ADDENDUM No. 2

2017 AERIAL SEWER REPLACEMENT PROJECT
CITY BID NUMBER WS-2014-42
CITY OF RALEIGH

AECOM PROJECT No. 60533600
BID DATE: APRIL 25, 2023
ADDENDUM DATE: APRIL 18, 2023

6 CROSS SECTION DETAIL STREAM BANK
NOT TO SCALE

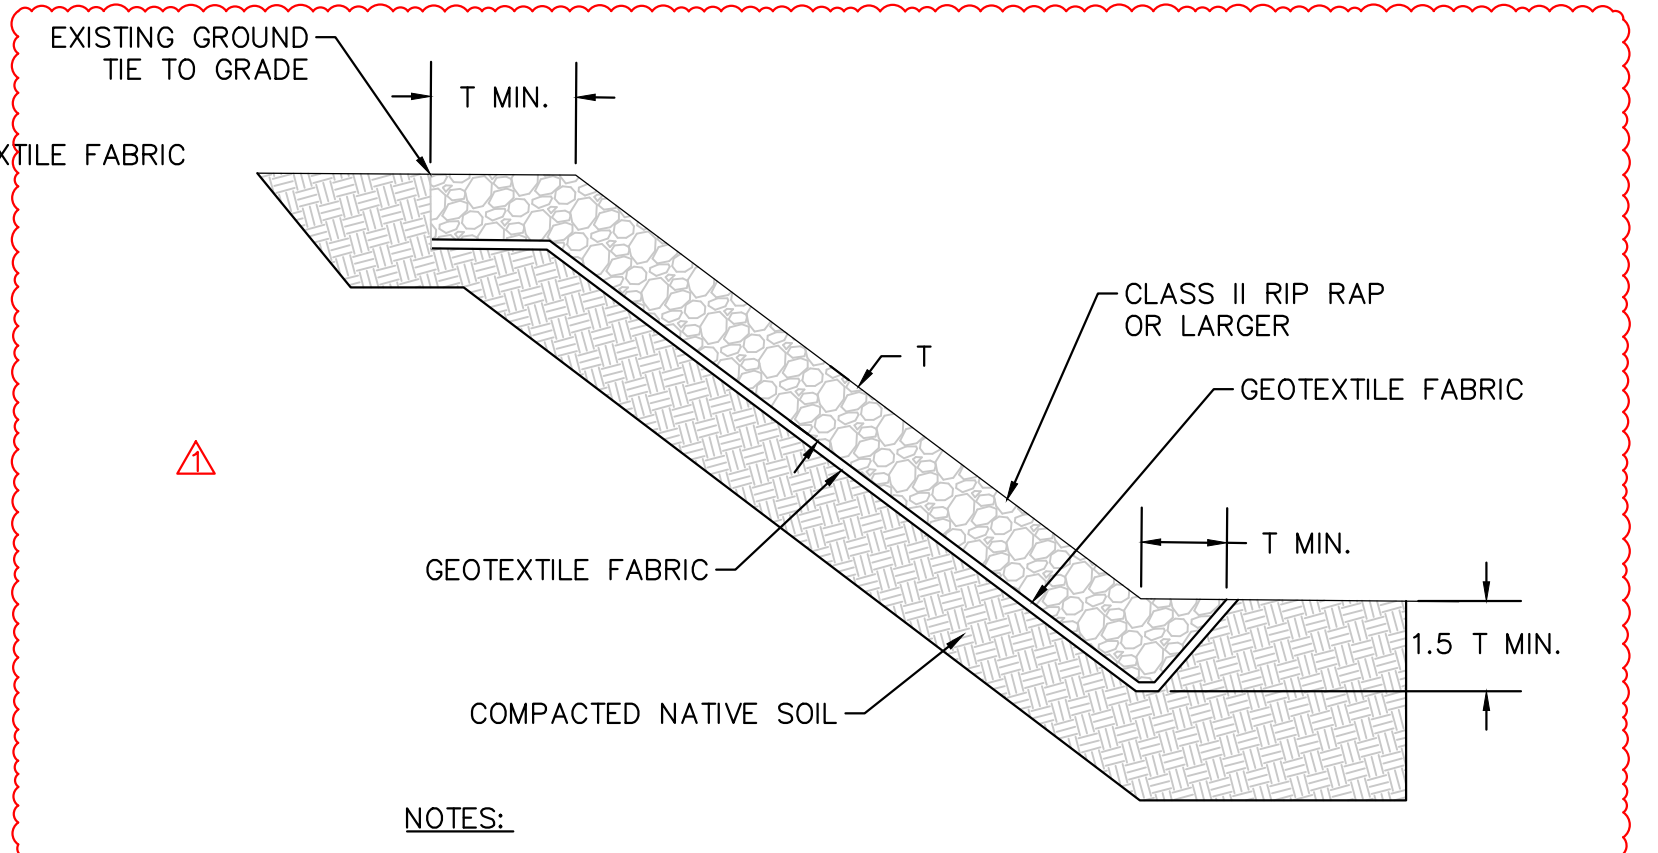
SECTION	DESCRIPTION
General	This Addendum forms a part of the Contract Documents and modifies the original Bidding Documents as noted below. Bidders shall acknowledge receipt of the Addendum in the space provided on the Proposal Form (00410, Page 2). Failure to do so may subject the Bidder to disqualification.
Pre-Bid Conference	The Mandatory Pre-Bid Conference Was held on Thursday, April 6, 2023, at 10:00 a.m. in the parking lot of St. Michael's Episcopal Church, 1520 Canterbury Road, Raleigh, NC 27608. Attached is a copy of the Attendance List sheets, and the Pre-Bid Conference Notes.
Contract Plans	
General Questions	Question: Are any trees or plantings on any of the site required to be replaced? Response: No trees or plantings are to be replaced on any of the work areas, other than what is required on Erosion & Sediment control drawings CU-501 through CU-505.
Plan Sheet CU-104	Note No. 5: At end of note add the following: "See Detail 6, Sheet CU-504."

Plan Sheet CU-504	Replace Plan Sheet CU-504 with the attached Revised Plan Sheet CU-504. Revisions were made to Detail 6 – Cross Section Detail Stream Bank.
Contract Specifications	
Section 00410 Bid Form	Replace Section 00410 – Bid Form in its entirety with the attached Revised Section 004100 – Bid Form. Use the revised form for bid submittal. Revisions were made to the Unit Price Bid Schedule as follows: <ol style="list-style-type: none">(1) Bid Item 24; Added "(Cementitious Liner)" to the description.(2) Bid Item 49; Added additional description.(3) Bid Item 51; Changed the Bid Unit Price from \$50,000 to \$60,000 to match the Extended Bid Price.(4) Added Bid Item 52 – Rip Rap Slope Protection.

NO.	REVISIONS	DATE	BY
1	REVISED DETAIL 6 PER ADDENDUM #2	4/18/23	CJP

- NOTES:**
- RIP RAP AND GEOTEXTILE ALONE SHOULD NOT BE USED ON SLOPES GREATER THAN 2H:1V.
 - ON SLOPES BETWEEN 2H:1V AND 1.5H:1V RIP RAP MAY BE BEDED IN 6" OF #57 STONE. CONSULT ENGINEER PRIOR TO INSTALLATION.
 - THICKNESS OF RIP RAP (T) SHOULD BE NO LESS THAN 1.5 X D50 (APPROXIMATELY 21" FOR CLASS II).
 - DEPTH OF THE TOE SHOULD BE APPROXIMATELY 1.5 X THICKNESS (APPROXIMATELY 30" FOR CLASS II).
 - RIP RAP SLOPE PROTECTION IS MODIFIED FROM VDH&T AND NDEQ LAND QUALITY SECTION EROSION AND SEDIMENT CONTROL DESIGN MANUAL.
